# **Addendum to Appendix D**

## **Technical Alignment Report**

*Prepared by*  
Alaska Department of Transportation and Public Facilities  
6860 Glacier Highway  
Juneau, Alaska 99801-7999

This addendum outlines changes to the design criteria, updates the alignment discussion where changes have occurred, provides updated bridge summaries, provides updated plan and profile sheets where changes have occurred, updates ferry terminal layouts and cost estimates, updates the Engineer's Estimate, and provides an errata sheet for the original technical report.

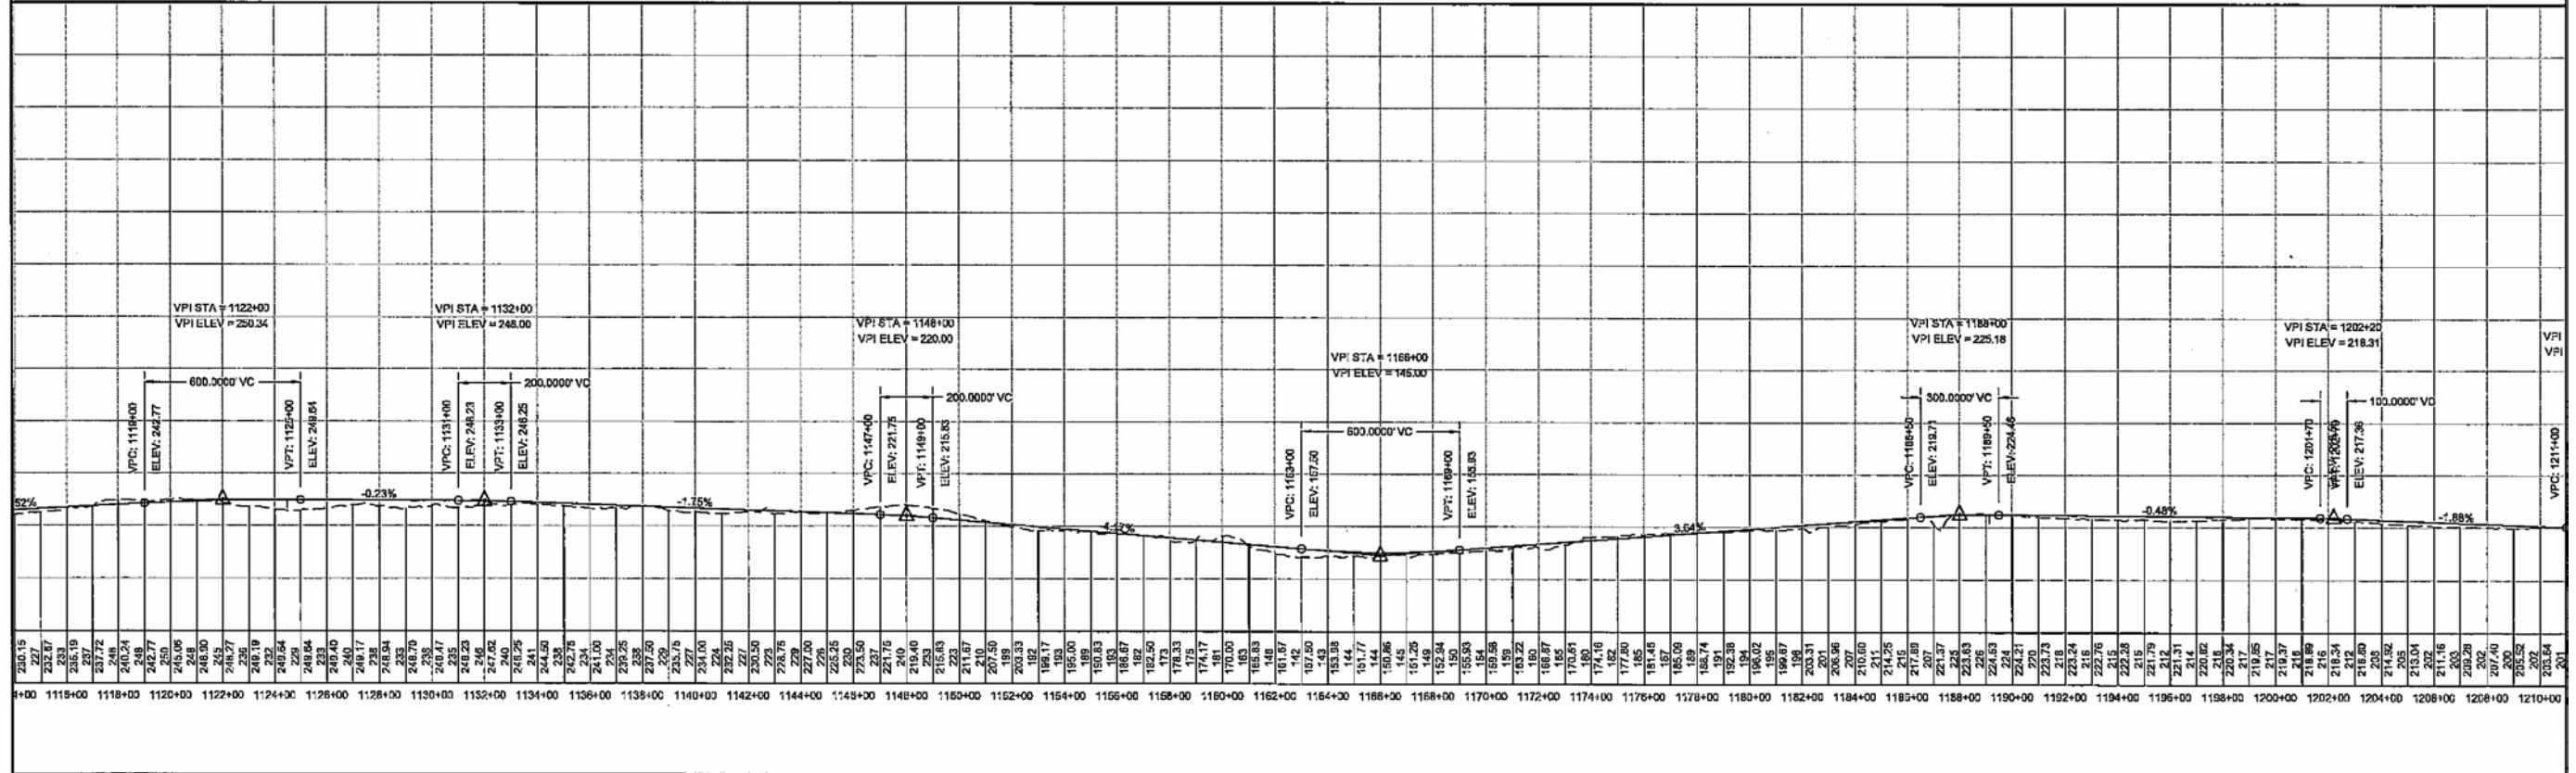
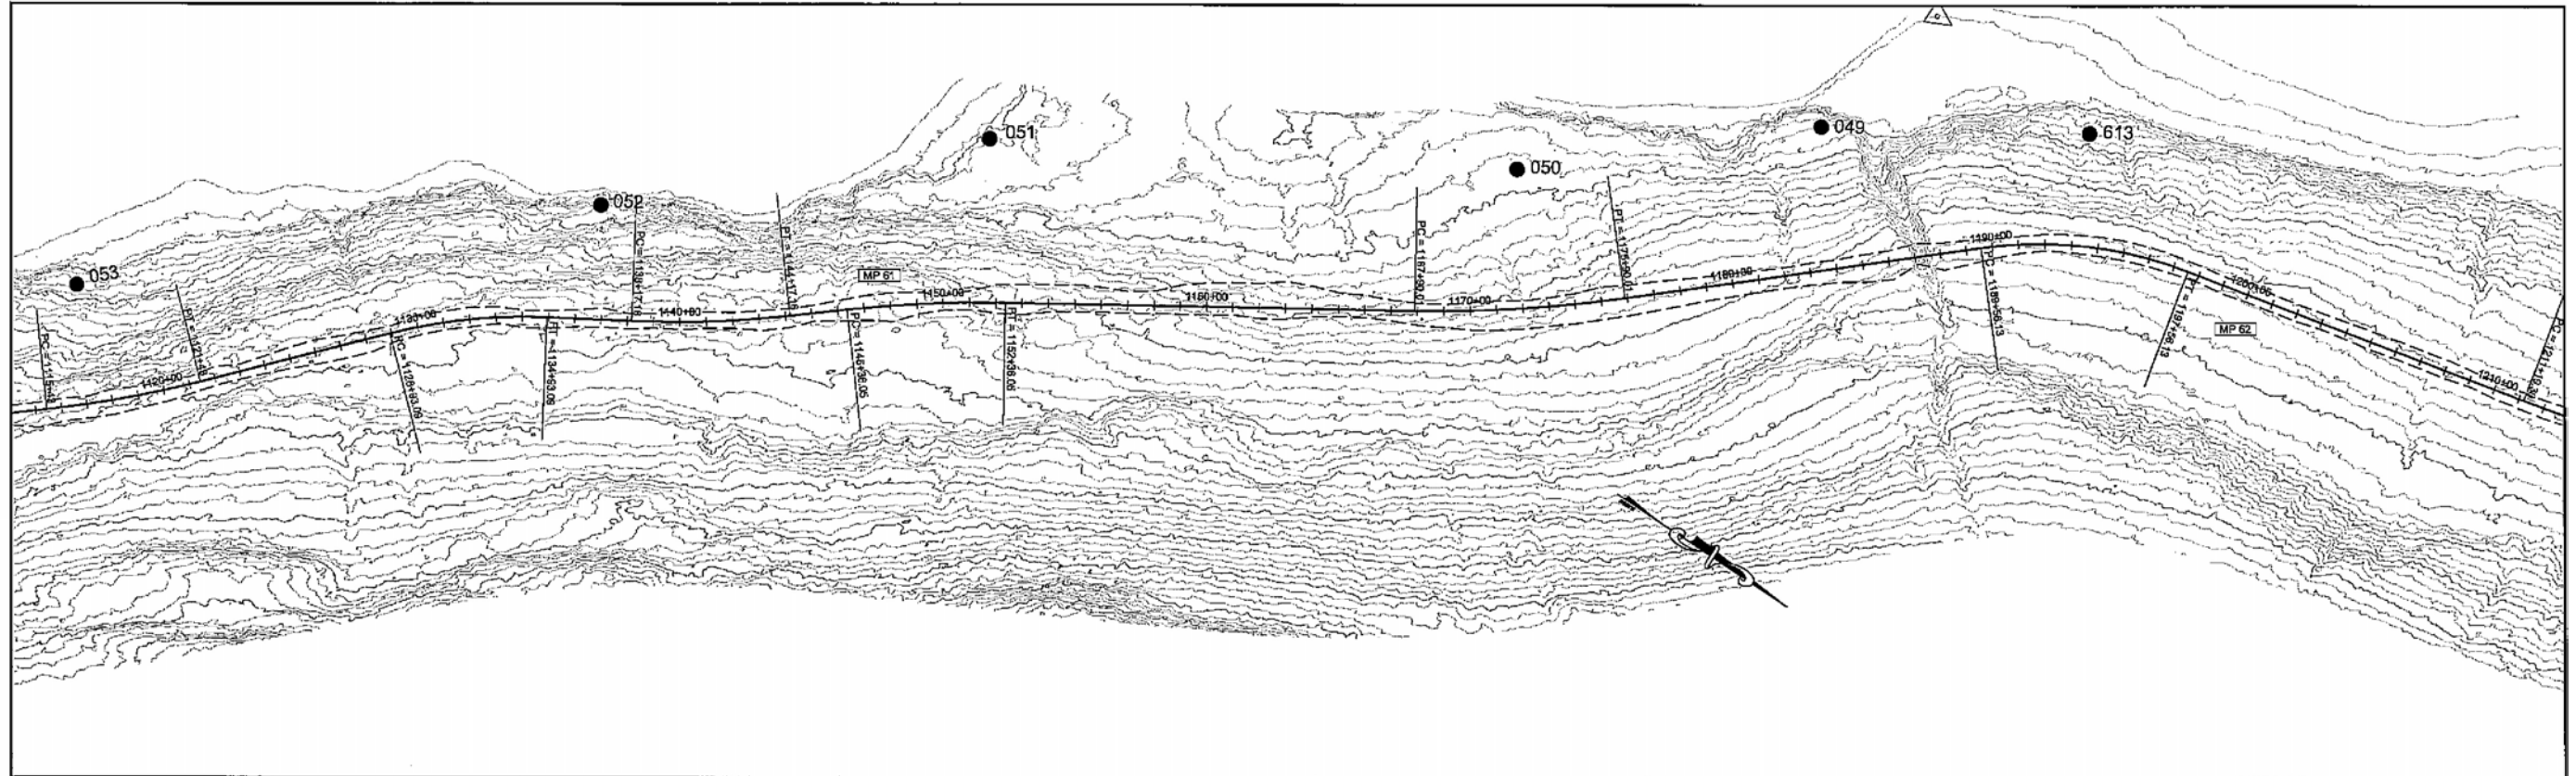
**Station 561+00 (MP 49.9) to Station 754+50 (MP 53.6) - Berners Bay Crossing** – This segment was lengthened to 3.7 miles as a result of major alignment revisions, the first of which was outlined in the preceding segment description. This revision moved the alignment off of steep slopes onto relatively flat, timbered uplands.

This realignment also provided a more desirable crossing over the anadromous fish stream here by reducing the skew of the bridge in relation to the stream channel. The bridge length remains at 130 feet.

The crossings over the Antler/Gilkey River and the Berners/Lace River were revised to address resource agency concerns. These revisions increased the bridge lengths to 2,600 feet and 2,750 feet, respectively.

Two new bridges were added to span high use bear trails. The first bridge, located at Station 669+08, crosses an Anter/Gilkey River overflow channel and associated bear trail, and has a preliminary length of 146 feet. The second bridge is a 100-foot-long structure that crosses a bear trail near Station 692+50.

Revised Plan and Profile Sheets for this segment (Sheets 8-9) are included in Attachment A.

**Station 754+50 (MP 53.6) to Station 1390+00 (MP 65.6) - Berners Bay Crossing to Independence Lake** – This 12.0-mile segment was revised at multiple points to minimize or eliminate impacts to wetlands along the segment. The Revised Plan and Profile Sheets (Sheets 9-13) are included in Attachment A.

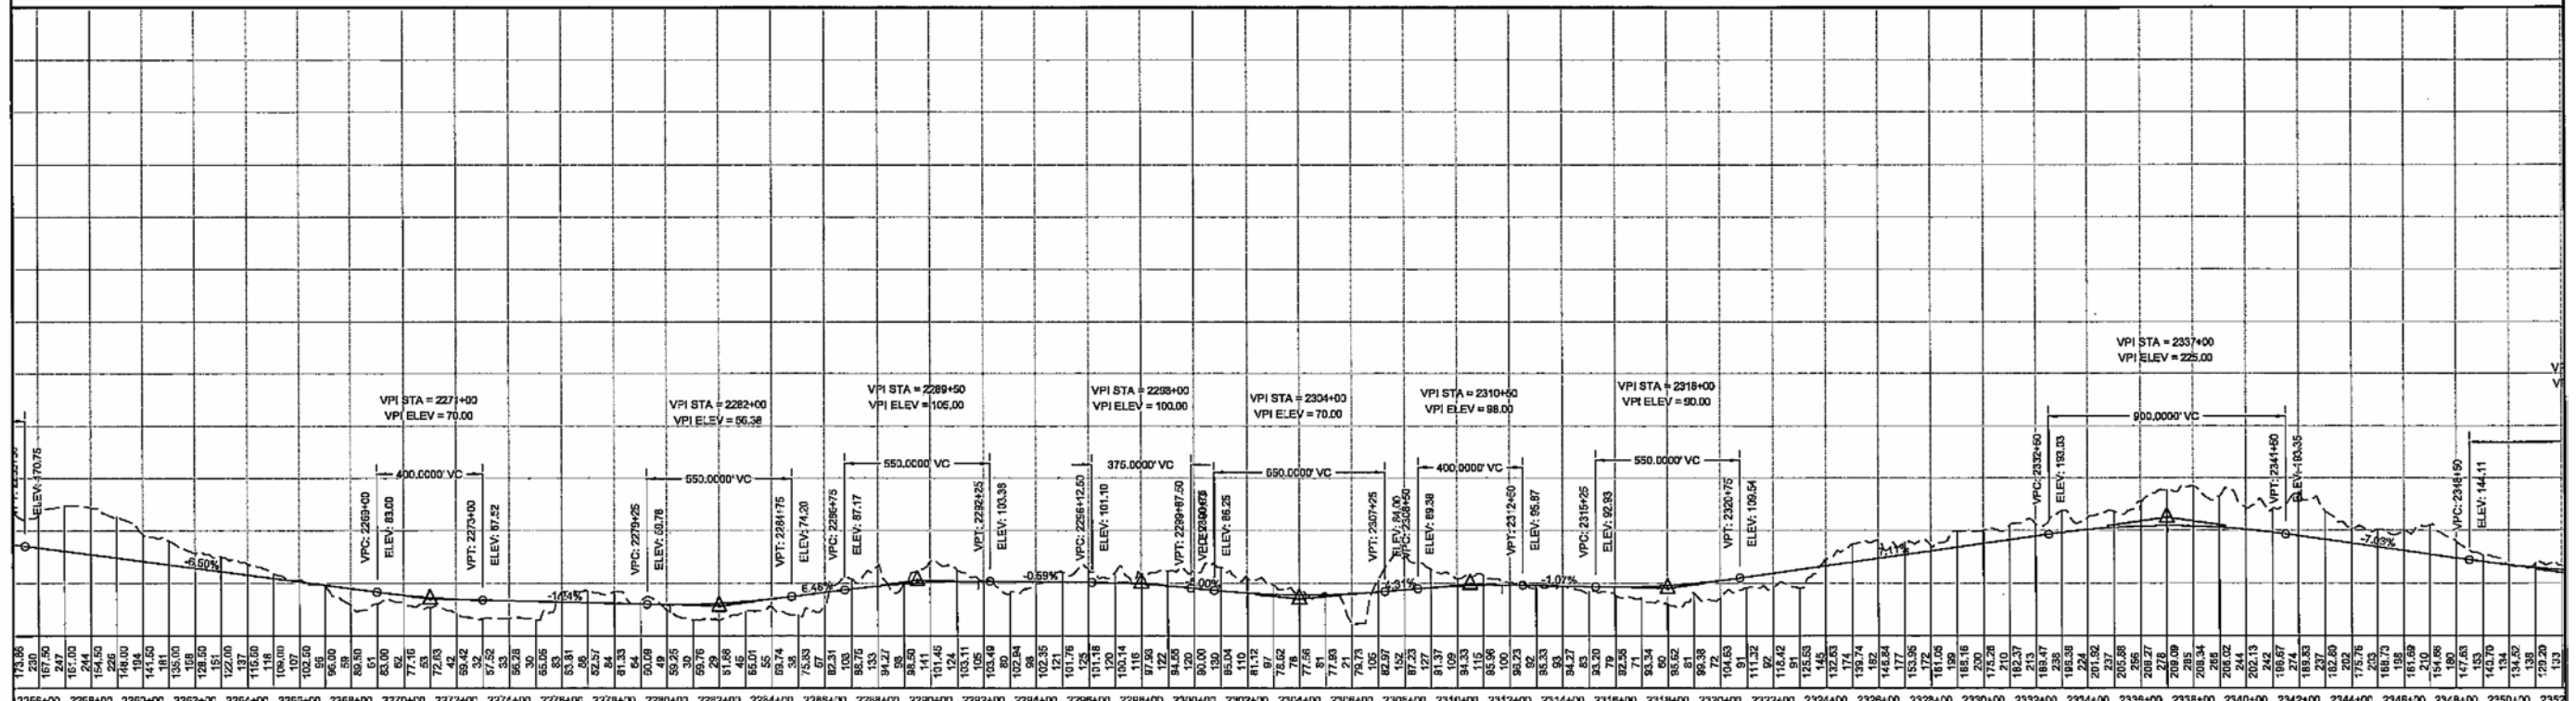
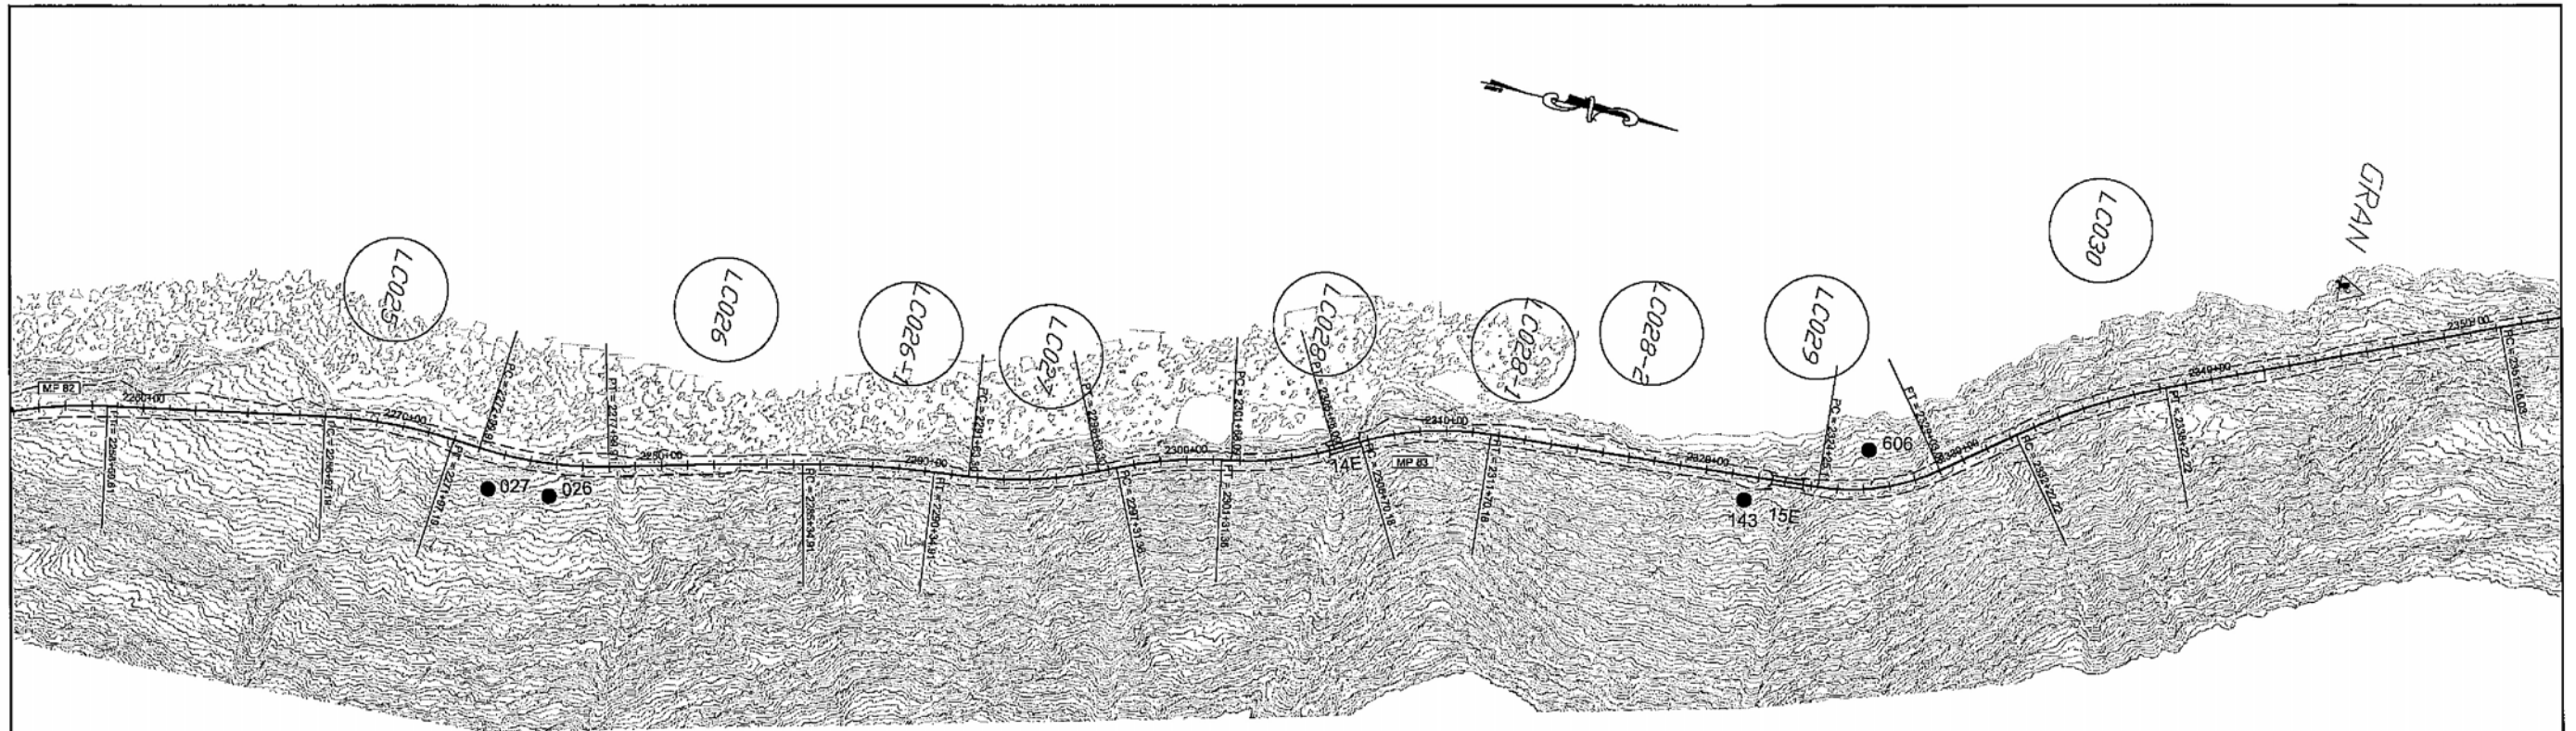
**Station 2150+00 (MP 80.0) to Station 2610+00 (MP 88.7) - Level Point to Katzehin River** – A new eagle nest at Station 2321+59 forced a downhill shift of the alignment at this location.

The Revised Plan and Profile Sheet for this segment (Sheets 25 and 28) are included in Attachment A.

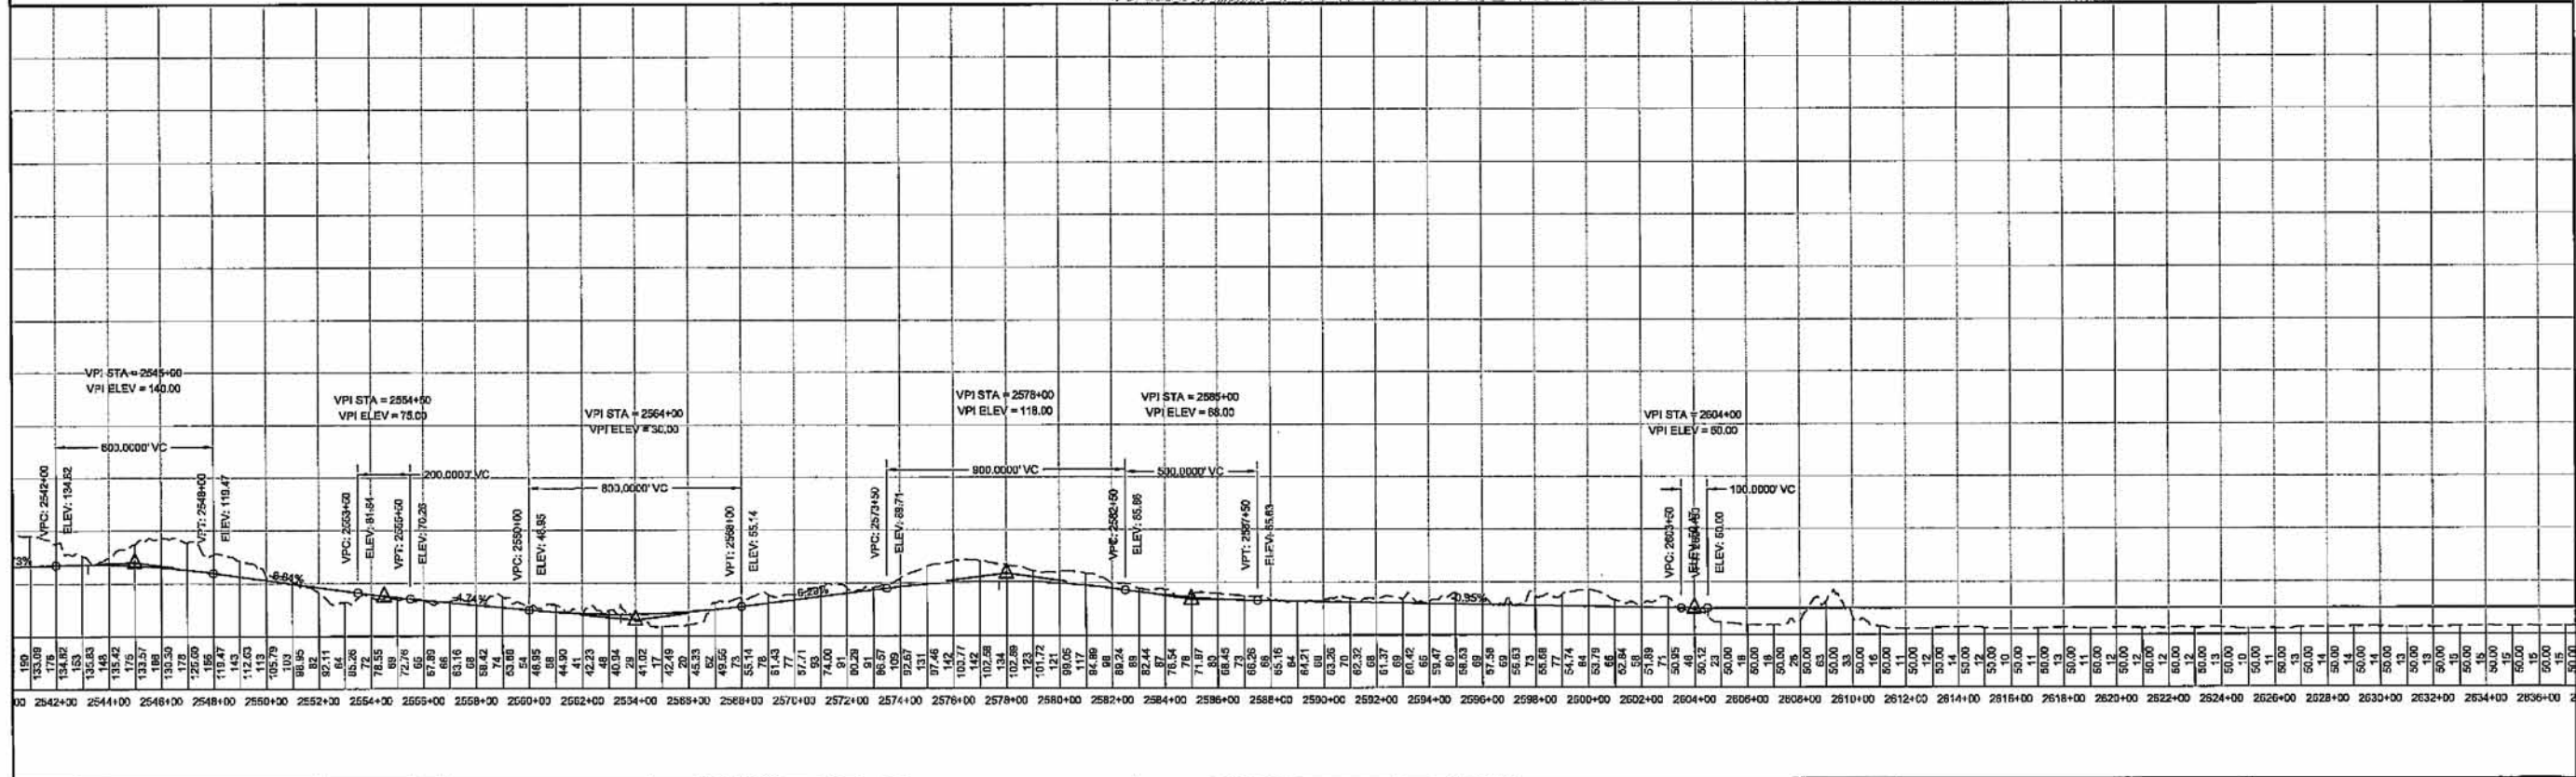
The alignment was also moved slightly uphill between Station 2574+00 and Station 2610+00 to eliminate marine wetlands impacts in some areas, and minimize them in others.

**Station 2610+00 (MP 88.7) to Station 2747+00 (MP 91.3) – South Katzehin River to Katzehin Ferry Terminal** – The alignment on this segment was shifted to the northeast between Station 2610+00 and Station 2740+00 to eliminate estuarine wetlands impacts between Station 2700+00 and Station 2720+00. This shift required a reorientation of the Katzehin River Bridge. This reorientation, and an adjustment in the bridge abutment location to satisfy resource agency concerns, resulted in the bridge length being increased to 2,500 feet.

Revised Plan and Profile Sheets for this segment (Sheets 28-30) are included in Attachment A.
